NO.	DESCRIPTION	DATE
1	ADD #1	08/27/25

ANCHOR PARK
CONCESSIONS AND TEAM ROOM FACILITY
PORT WENTWORTH, GA

SHEET
E200

OVERALL POWER & SYSTEMS PLAN

1
E200
OVERALL POWER & SYSTEMS PLAN
1" = 20'-0"

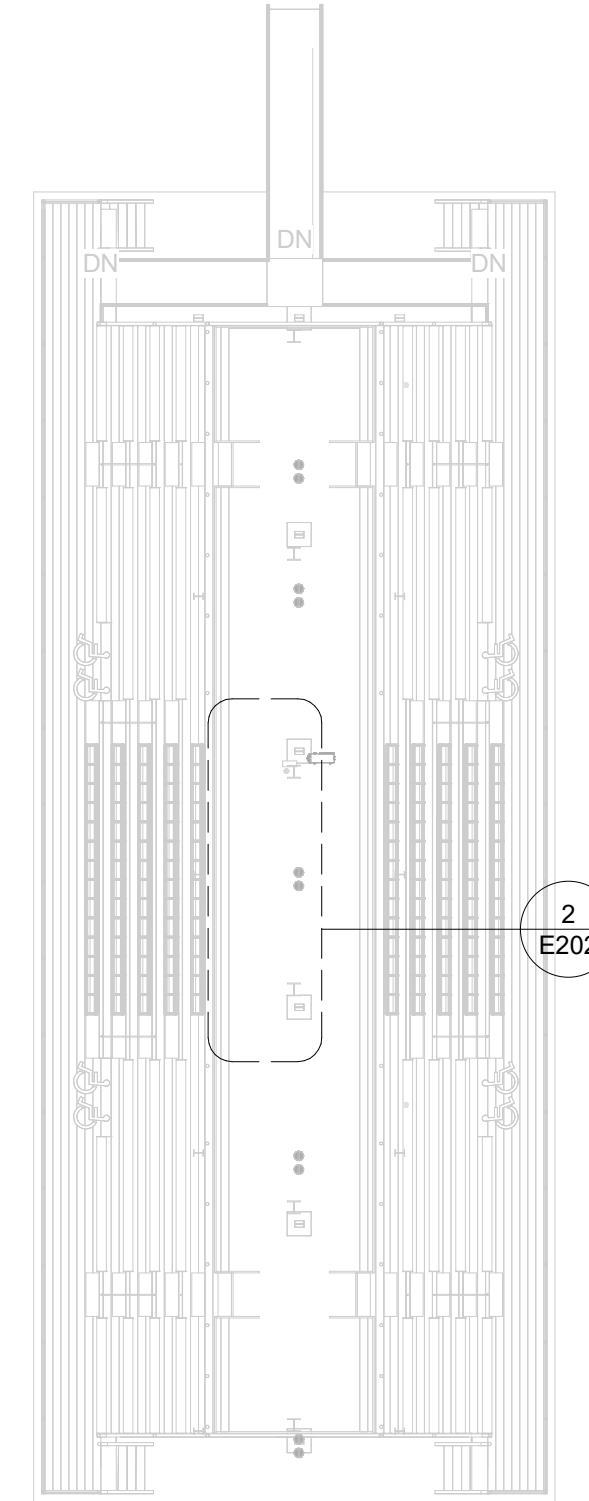
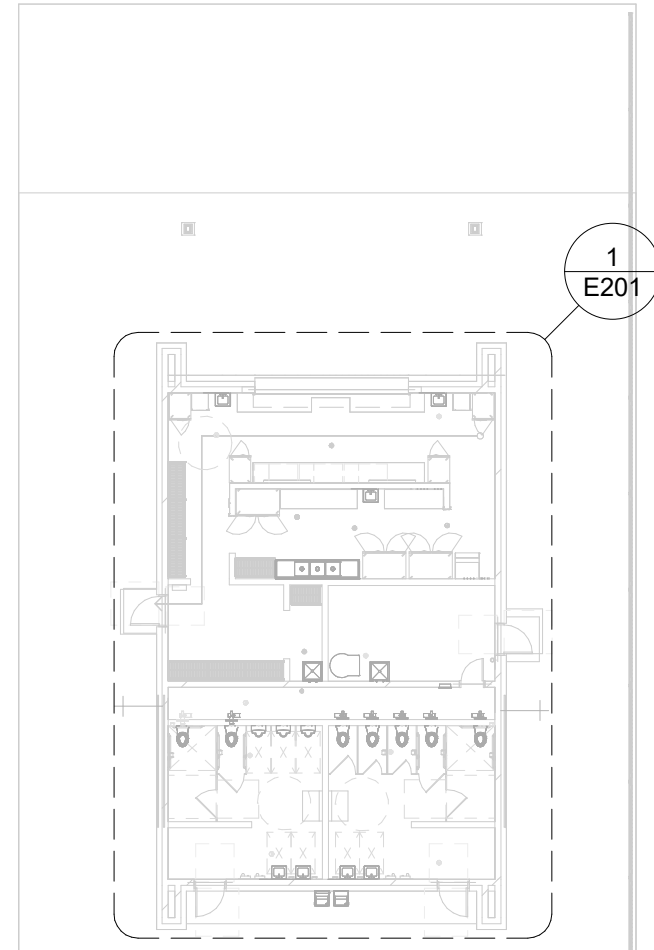
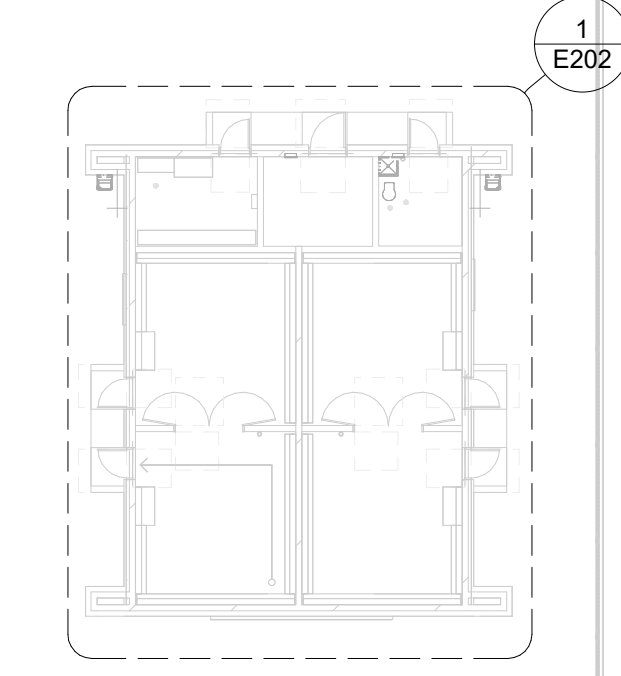
#	DESCRIPTION
338	ROUTE (1) 3/4" CONDUIT-3#10 AWG, 1#10G FROM PANELBOARD TO GRINDER STATION. COORDINATE FINAL LOCATION WITH CIVIL ENGINEER.
